Planning Decisions Committee

6.30pm, Wednesday 25 August 2021

6.1 PLN17/1016.02 - 221 Swan Street Richmond - Section 72 Amendment to Planning Permit PLN17/1016 for alterations and additions to the approved multi-storey building with roof terraces.

Figure 1: Proposed elevations of amended development (Applicant Submission, October and November 2020)

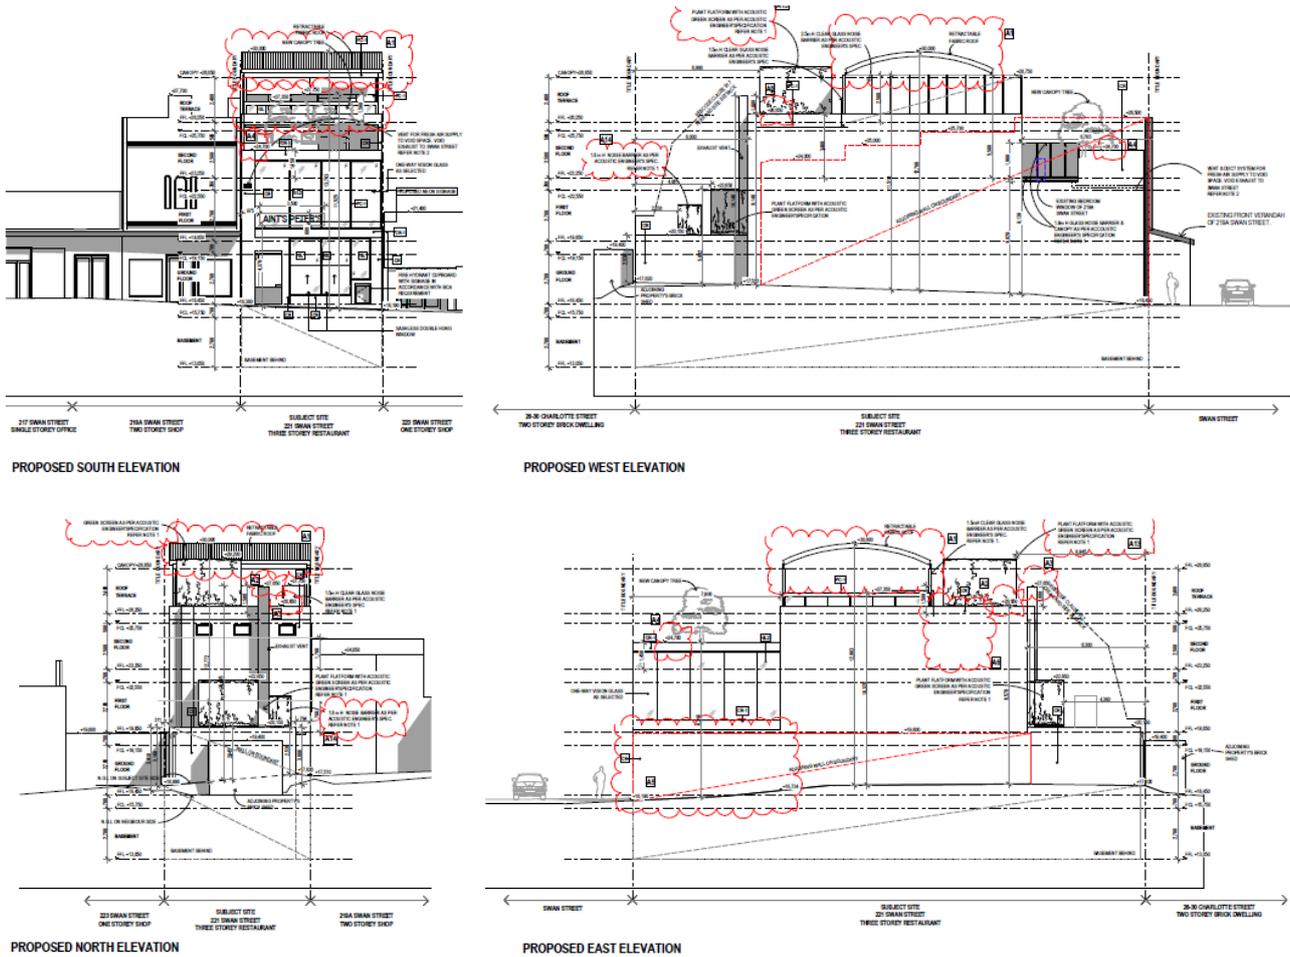
- (ii) Incorporate new fire hydrant cupboard along front façade.
 - (iii) Change concrete roof over ground floor kitchen to a metal roof.
- (d) Specifically, at first floor (Mezzanine plan as shown on floor plan):

- (i) Deletion of two north-facing windows.
 - (ii) Reconfiguration of mechanical equipment over ground floor kitchen, including relocation of solar panels and roof hatch, as well as the inclusion of a screen/noise barrier that would be 1.2m higher than the top of the fan (notated as OAF-1 on plan)

- (e) Specifically, at second floor (Roof terrace plan as shown on floor plan):
 - (i) Finished floor level consistent throughout entire level, i.e. +23.250.

- (ii) Deletion of previously proposed mobile planter boxes along southern perimeter and retractable fabric roof to outdoor dining area.
 - (iii) Increase height of southern perimeter balustrading from 1.1m to 1.45m above Finished Floor Level (FFL +23,250).

- (iv) Relocate bathroom amenities from northern portion of the level to the eastern boundary and extend seating.
 - (v) Change northernmost section of retractable and metal roof to a fixed glass and metal roof. Above the new metal roof portion will be a plant platform with a 1.75m high green screen and noise barrier.

- (vi) The 3 north-facing windows to be fixed, unopenable.
- (f) Specifically, at roof terrace level (Roof plan as shown on floor plan):
- (i) Increase height of southern perimeter balustrading from 1.1m to 1.5m above FFL.

- (ii) Change profile and material of canopy- from a timber canopy with retractable fabric roof to a metal canopy with retractable fabric roof. The new canopy will have a maximum height of 13.763m above Natural Ground Level (NGL) (+30,000) as taken from Swan Street.

- (iii) Install a new plant platform to the north of the metal canopy, as well as the inclusion of a screen/noise barrier that would be 1.75m higher than the top of the tallest mechanical plant (notated as KEF-1 and KEF-2 on plan).

Figure 5: Figure 2 to Design and Development Overlay Schedule 17 – Residential interface direct abuttal (Yarra Planning Scheme, DDO17, C236, 23 November 2018)

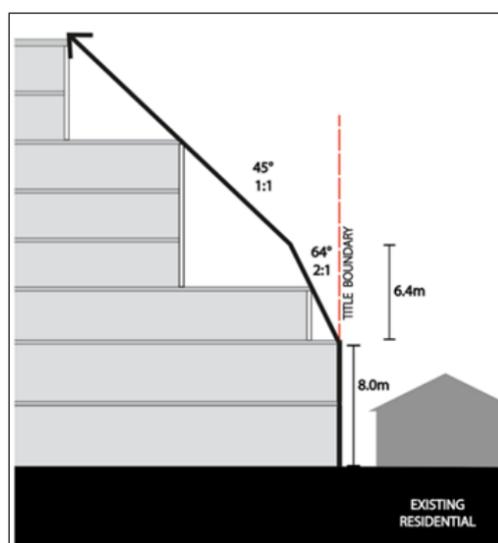
102. Directly to the north of the subject site at No. 26-28 Charlotte Street is a double-storey residential building located within a General Residential Zone (Schedule 2). The side and rear wall height and upper level setback requirements of the DDO17 provide the relevant tests for assessing visual impact of new development with a common boundary to a property in a residential zone. As specified in Table 2 to Precinct 2 (Swan Street Activity Centre), the rear wall abutting the residentially zoned land should not exceed a maximum height of 8m on the common boundary and should be setback in accordance with Figure 2 in the schedule to DDO17.

Figure 6: Proposed east elevation with Figure 2 to DDO17 setback diagram drawn in green and mechanical equipment/green screening shown in blue (Applicant submission October and November 2020 with officer's annotations)

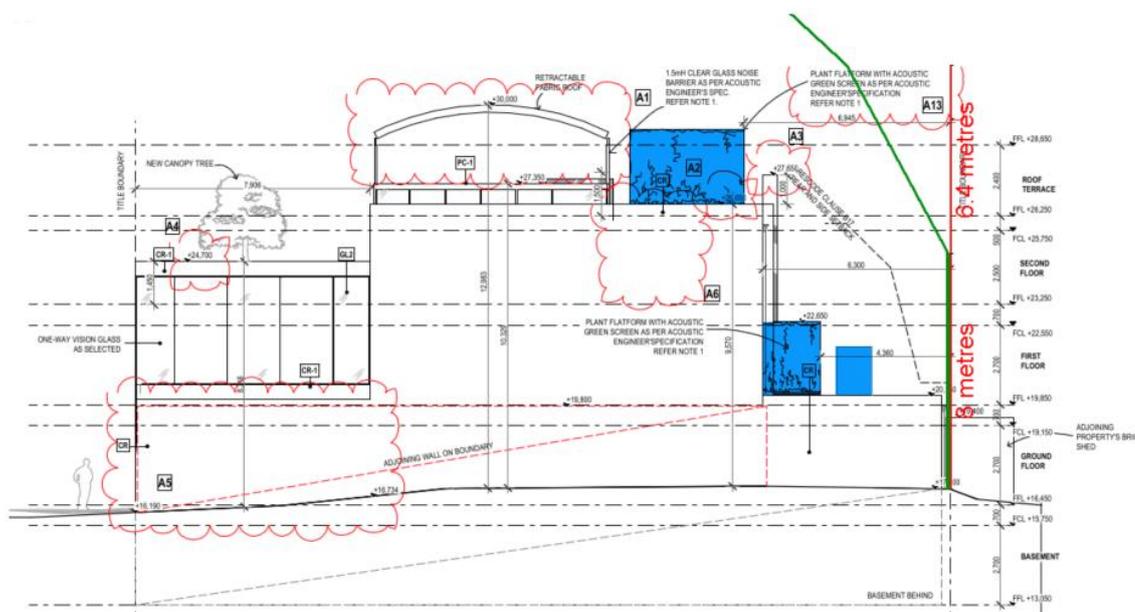
103. Under the amendment, the proposed rear ground floor boundary wall continues to have a height between 2.53m and 3.16m, which is well within the 8m maximum height encouraged under DDO17. At the upper levels, the rear, northern wall will increase in height from 8.63m-9.26m to 9.03m-9.66m whilst maintaining the previously approved setback of 6m-6.3m from the northern boundary. The proposed relocation and addition of approved and new plant equipment will be located towards the rear of the development at first and roof terrace levels. As shown in the figure below, the amended development continues to fully comply with the setback under Figure 2 of DDO17.

104. With regard to the side boundary walls, the increases in wall heights along the eastern and western boundaries, including the new plant screen along the eastern boundary are acceptable given they abut existing built form located within a Commercial 1 Zone, and not residentially zoned land. Therefore, the changes proposed to the side boundary walls will not cause unreasonable visual impact on the adjoining properties.

Figure 7: Mechanical plant acoustic screen locations – first floor (top) and roof terrace (bottom) (Cogent Acoustic, 22 June 2021)

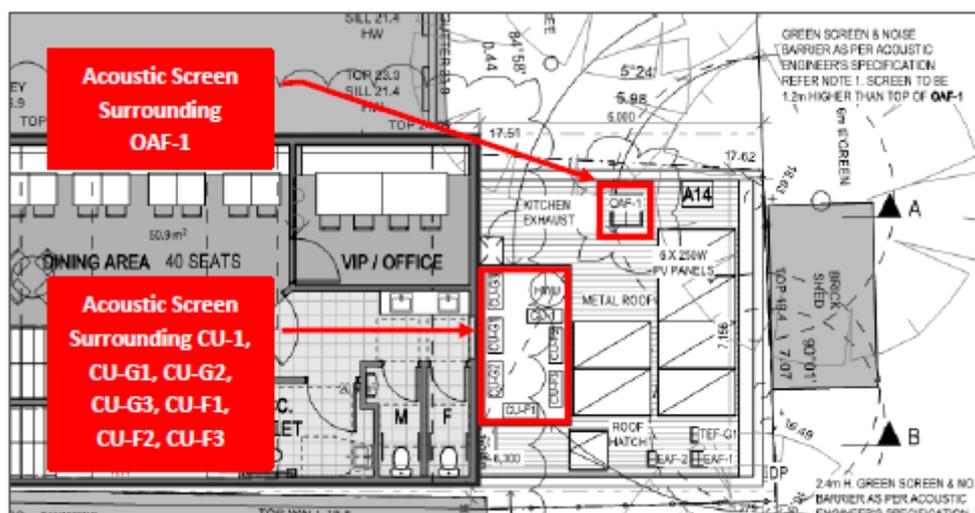
113. Roof-mounted mechanical plant (as shown in figure 7 below)
- Acoustic screens to be installed surrounding three locations of mechanical plant equipment at first and roof terrace levels.

- Plant equipment CU-1 at first floor to operate in 'Night mode' during the SEPP N-1 'Night' period (after 10 pm every night) to reduce the Sound Power Level to less than 73 dB(A) and (Toshiba MMY-MAP1206FT8P-A is capable of this)

- Inclusion of timers to the following plants to limit the fan speeds during the SEPP N-1 'Night' period:
 - OAF-1 (first floor) to approximately 1200 RPM

- KEF-1 (roof terrace) to approximately 1100 RPM

117. However, Council's acoustic consultant queried the change to the provision of noise limiters, with the amended acoustic report recommending these for external loudspeakers, and not for internal dining spaces. Condition 9d of the permit requires "*the provision of electronic noise limiters/compressors on the amplifiers/speakers within the indoor and outdoor dining areas of the venue with setup guided by an acoustic consultant prior to operations commencing.*" SLR Consulting recommends maintaining compliance with this condition to ensure that noise limits are appropriate in the context of the development and the surrounding area. This will be required by way of a permit condition should an amended permit be issued.

118. Given the proximity of residents to the subject site and the large extent of both plant equipment sources, as well as patron and music noise sources, SLR Consulting has recommended that a post development noise assessment of all noise generating sources be undertaken to ensure compliance with the relevant noise limits. Should councillors be of the mind to support the application, this will be required by way permit condition on any amended permit to issue.
